Superfund Record of Decision:

Old Springfield Landfill, VT

REPORT DOCUMENTATION PAGE		1 REPORT NO. EPA/ROD/R01-90/033	2	3. Recipient's Accession No
4. Title and Subtitle SUPERFUND RECORD OF DECISION Old Springfield Landfill, VT Second Remedial Action - Final				5. Report Date 09/29/90

**VOC CONCENTRATION VERSUS TIME
SEEP LSE-04**

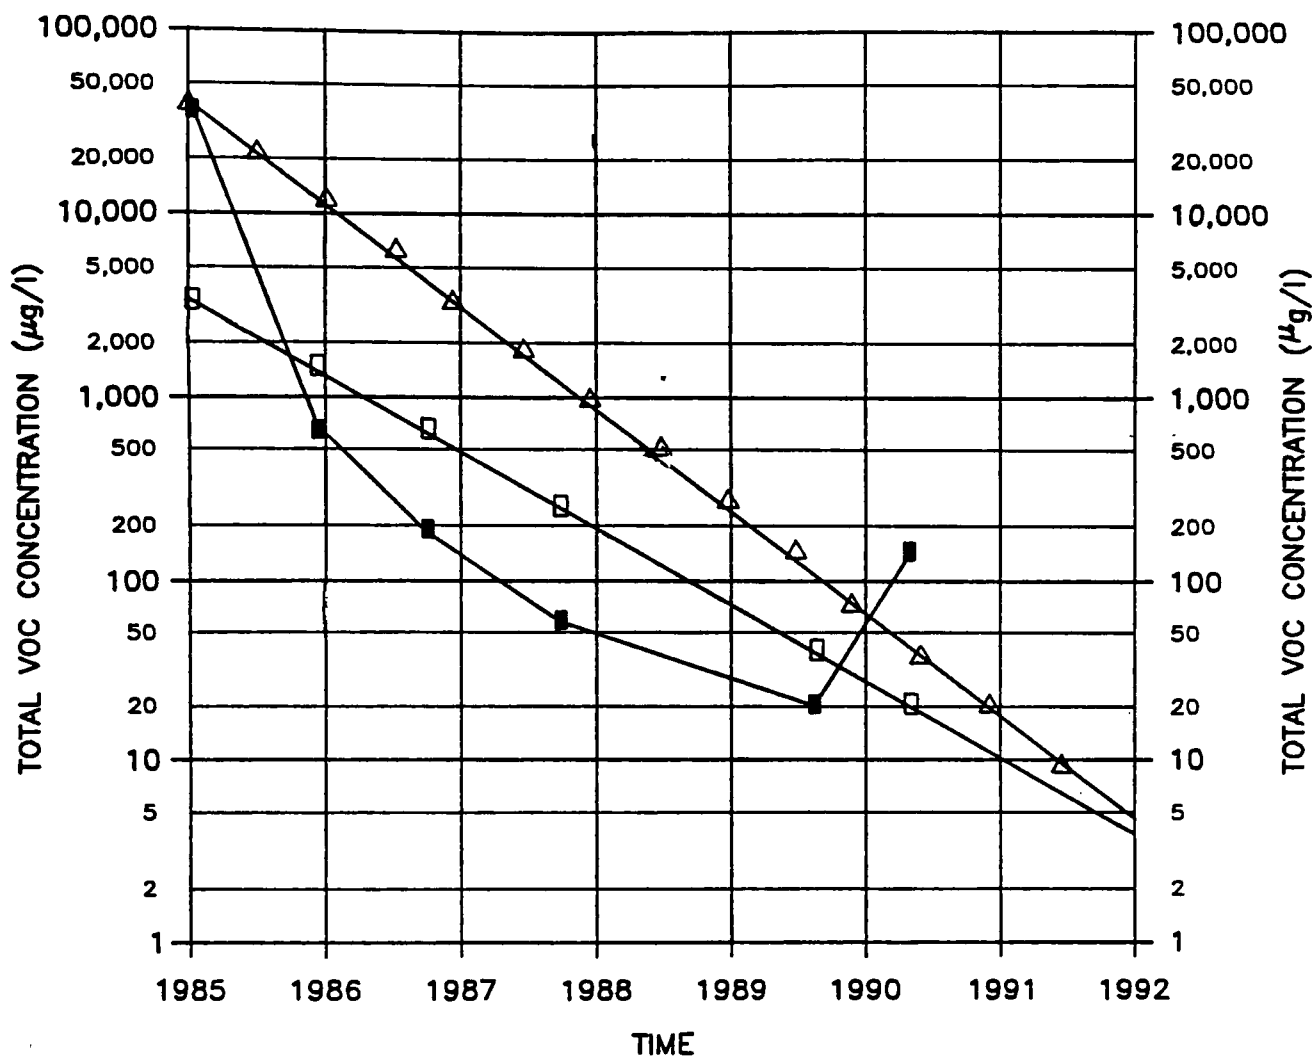
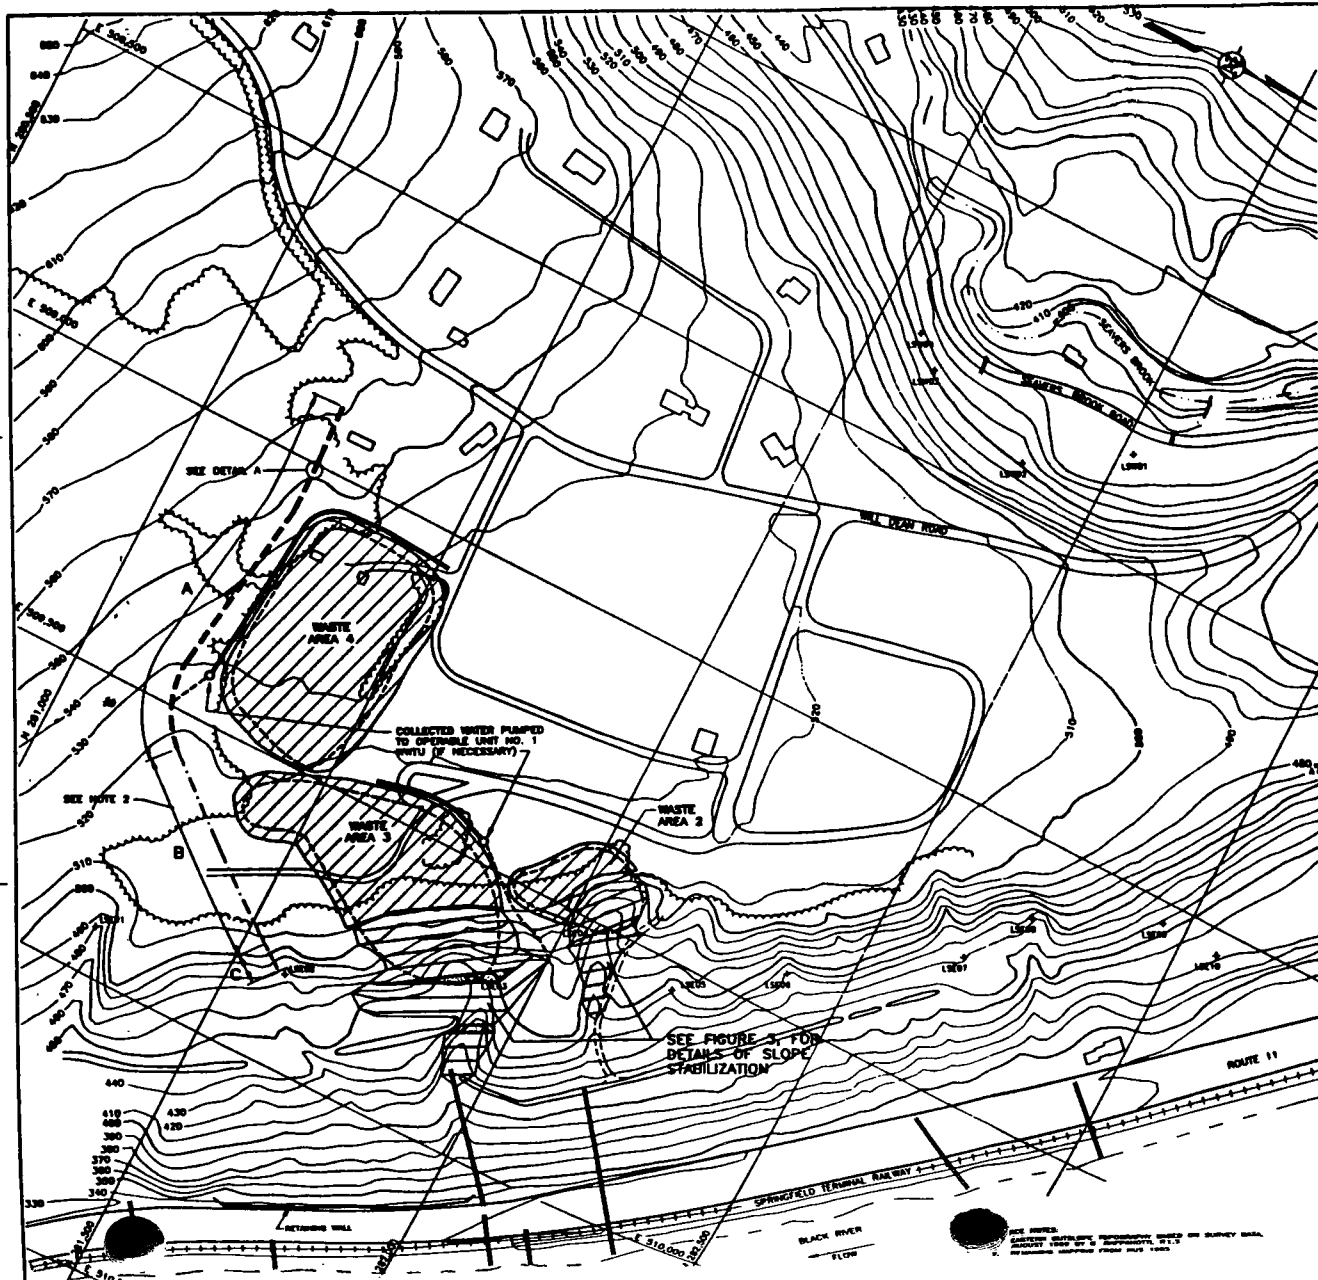
Figure 1 also presents the results of modeling desorption of VOCs from the solid waste in Waste Area 2 and into the water reflected by Seep LSE-04. This desorption modeling was performed by Remcor as a means to confirm the reasonableness of the source depletion model (i.e., regression analysis equation) presented in the FFS. As indicated in the attached Figure 1, there is good agreement between the results of the regression analysis and the desorption model. Both of these analyses reflect the significant decrease

First, as is clearly demonstrated in Figure 1 which accompanies the PRPs' desorption model discussion, the actual field data from LSE-04 do not closely coincide with model predictions. In particular, the most recent total VOC concentrations measured at LSE-04 are well in excess of 100 ug/l as compared to a model prediction of approximately 30 ug/l. Also important is the observation that the rate of yearly reduction of VOC concentrations at LSE-04 shows distinct evidence of slowing down. This "tailing effect" has been observed in VOC groundwater monitoring programs at other hazardous waste sites. It generally indicates a slowdown in the rate that groundwater contaminants are being flushed or removed from the wastewater system. At the Springfield site, this type of tailing effect will potentially have the effect of significantly prolonging (by years) the time required for total VOC concentrations at LSE-04 to decrease permanently to less than 5 ug/l.

ALTERNATIVE SLOPE STABILIZATION ILLUSTRATIONS
WASTE AREAS NO. 2 & NO. 3
OLD SPRINGFIELD LANDFILL SITE
SPRINGFIELD, VERMONT
PREPARED FOR
OLD SPRINGFIELD LANDFILL
SITE RESPONDENTS

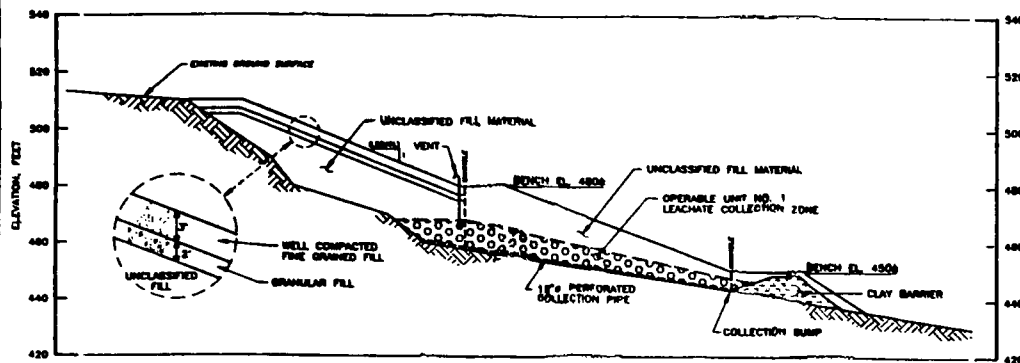
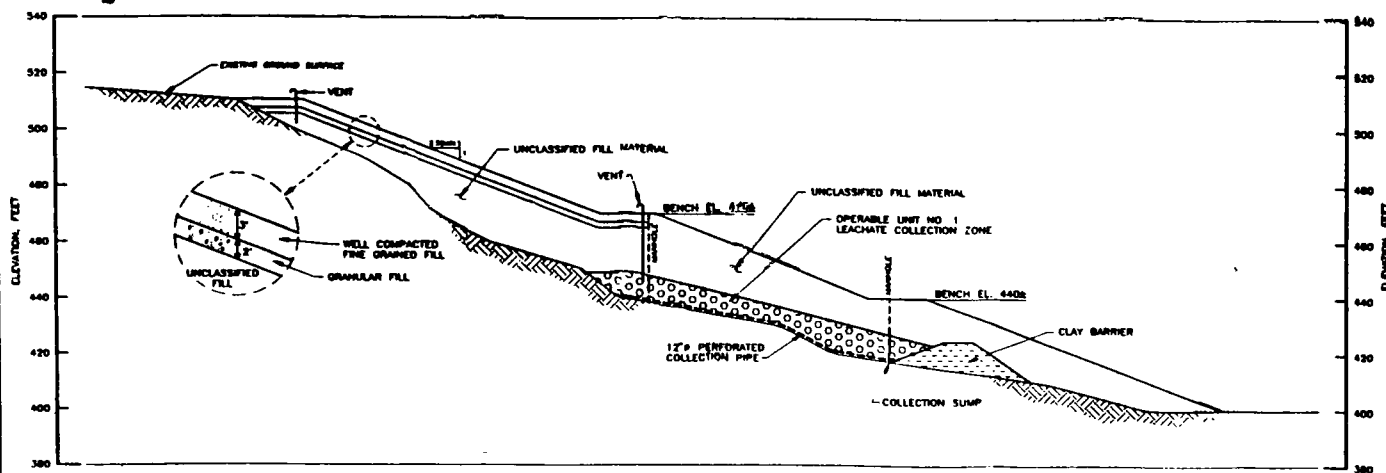
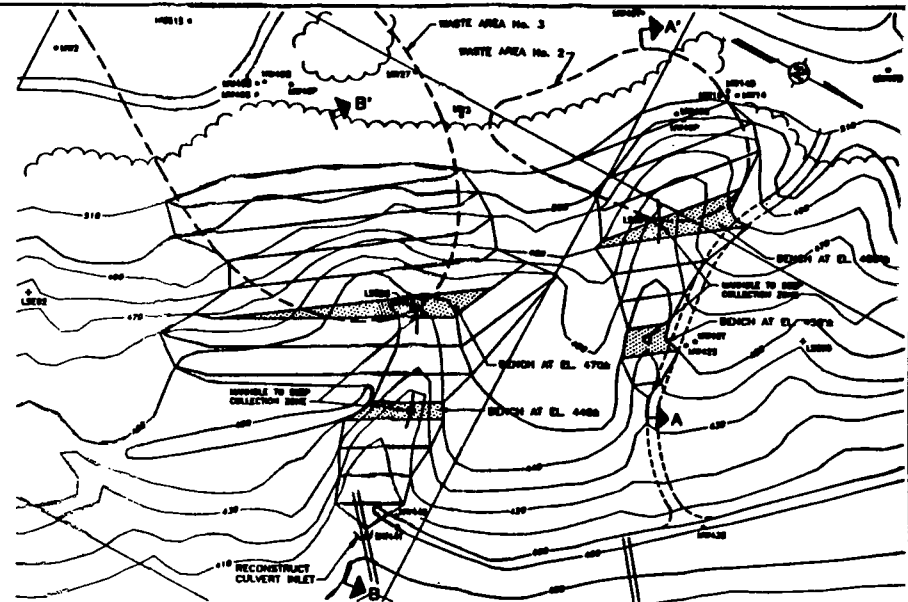
Clearly, therefore, even if the data provided in the EA are not entirely accurate, a passive gas collection system is adequate to remove whatever gas is generated within Waste Area 3. Further, Remcor's alternative design for outslope stabilization in Waste Area 3 can easily accommodate such a passive system as shown in Figures 2, 3, and 4, Detail G. Therefore, to the extent EPA shares the concern expressed in the SFS that the slope may not provide a stable base or access for equipment needed to install gas venting systems on the outslopes, that concern is misguided. Similarly, landfill gas emissions along the outslopes should not be a concern because, as described in Section VII.B above,

DETAIL C
FRENCH DRAIN
N.T.S.

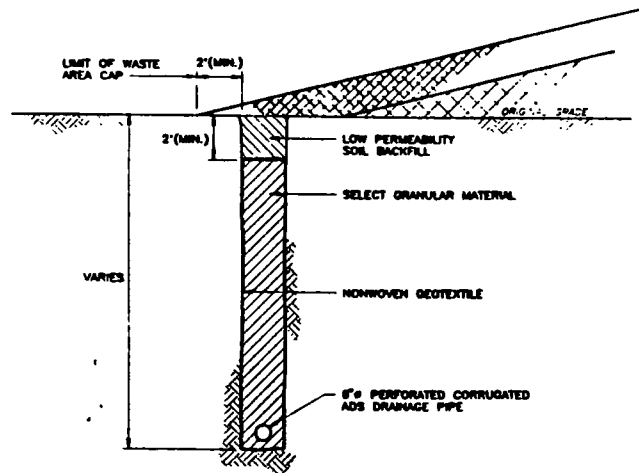
In contrast to the SFS design, the design proposed by Remcor in Figures 2 and 4, Detail C (attached) would provide a separate shallow surface water collection ditch along the uphill (western and southern) sides of Waste Area 4 for surface water diversion. This alternative design would eliminate the combination of surface and groundwater flows, reduce the size of the required hydraulic system, eliminate the need for a hydraulic barrier on the downgra-

For these reasons, the hydraulic requirements for a system designed to pump both surface water and groundwater (as proposed in the SFS) are much larger than those for a system capable of pumping groundwater alone (as proposed by Remcor). In the design presented in the SFS, the specifications include a 12-inch diameter pipe in the french drain and two 25-gpm pumps to pump the water from the drain to a discharge line. SFS, Section 5.3.1, at 26 and Figure 5-2. With a separate surface water diversion ditch, however, as Remcor has proposed, the piping in the french drain can be reduced from 12-inch to 6-inch diameter and the pumps can be reduced from 25-gpm to approximately 5-gpm capacity. Furthermore, these reductions are not offset by increased hydraulic requirements associated with the surface water diversion ditch, which can be designed for gravity flow rather than pumping of storm water flows. Reliance on gravity flow would also minimize operation and maintenance requirements and assure surface water diversion even when the pumps were inoperative (e.g., during power losses).

DETAIL F
SCALE: 1" = 10'

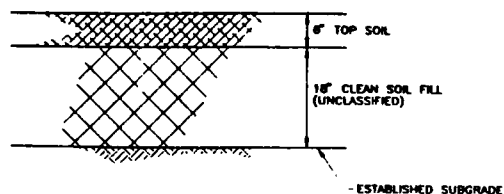
soil cover design that would be consistent with hybrid closure is included in Figure 4, Detail F (attached).
